Land Use Management Committee

Monday 2 May 2005

TO: Land Use Management Committee - 2 May 2005
REPORT: Environmental Services Division Report No. 18
SUBJECT: 33 Beatty Street, Balgowlah
FILE NO: DA382/04

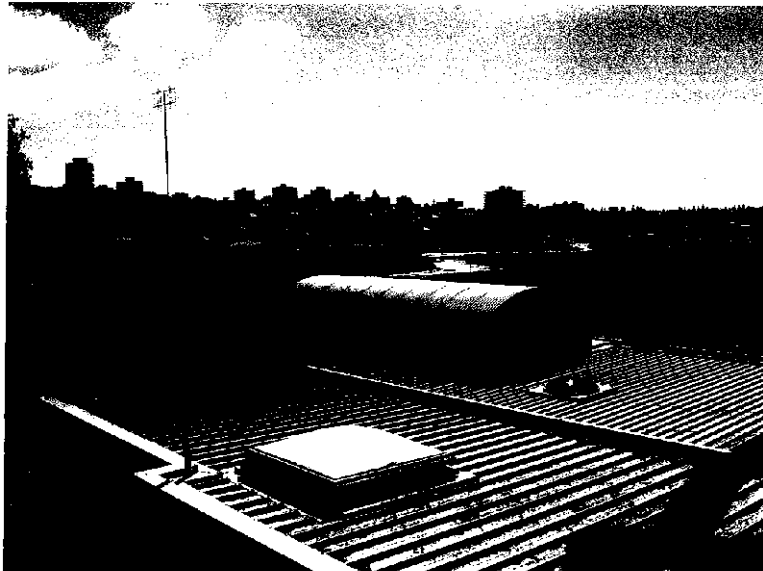
- We have left the roof height and design to the North side of the property untouched to ensure we do not impact 4 Tutus Street. We note that the covenant that 4 Tutus Street enjoys over this section of our property is based upon the floor height of the original building as of 1951. As there property is on a sloping block and the original house was set-back from the current property we have the opportunity to change the design of the current roof in this section which would impact their views. We have elected not to do this under the current scheme in consideration of their views. The picture below shows the current barrel roof which is proposed to remain unchanged.

Barrel roof remains unchanged thus ensuring the main views from 4 Tutus Street remain untouched

Landscape screening between 31 Beatty Street and 33 Beatty Street

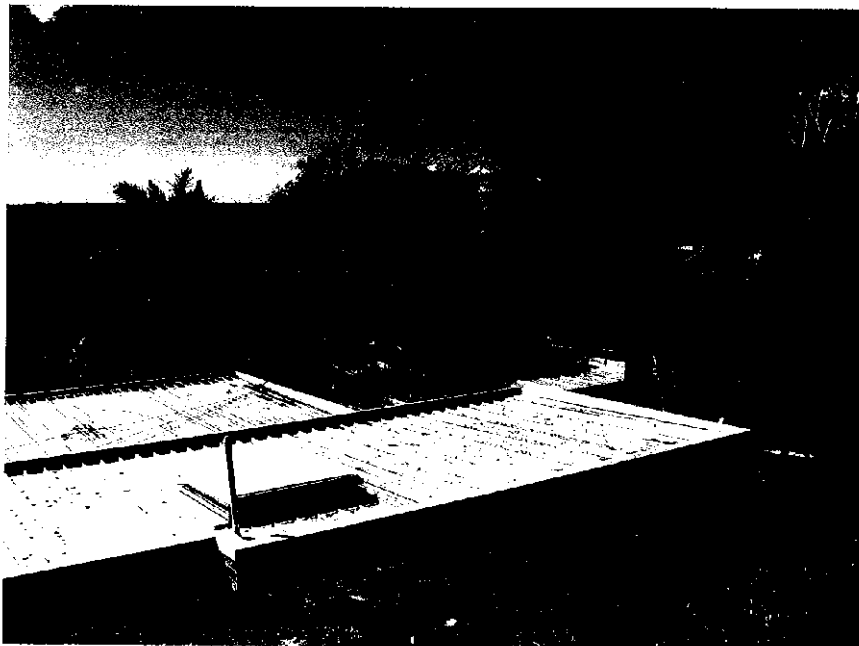
Our neighbours at 31 Beatty Street are concerned about loss of sunlight and loss of privacy. Our submission proposes a single story rumpus roof, setback on the block at the current height of the existing terrace. We already have views of their property as we are higher on the block than them, but the current landscaping offers both a level of privacy as shown below. We note that their building is in front of the building line on the street.

The roof of the proposed rumpus room is at the level of the brush fence. The set-back is to ensure there is no loss of sunlight and we have suggested further landscaping to ensure privacy is maintained. In consideration of their need to keep the garage terrace private we have brought back the rumpus room to the same position as the end of the brush fence.

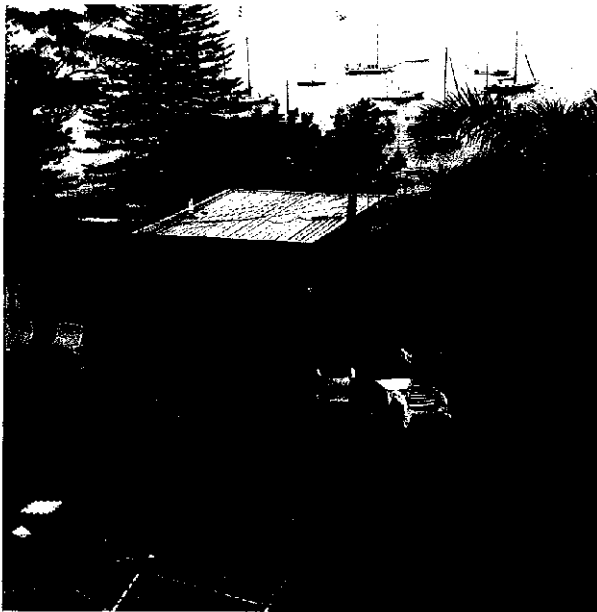
Our neighbour at 33a Beatty Street (Mrs Gottschald) is concerned about loss of privacy to their property. Our house currently has full visual access to their swimming pool and entertainment areas, as shown below.

Current view into 31a Beatty Street swimming pool area from our entertainment area

Current views into entertainment area of 33a Beatty Street from our terrace. This will be dramatically improved under the proposed scheme.
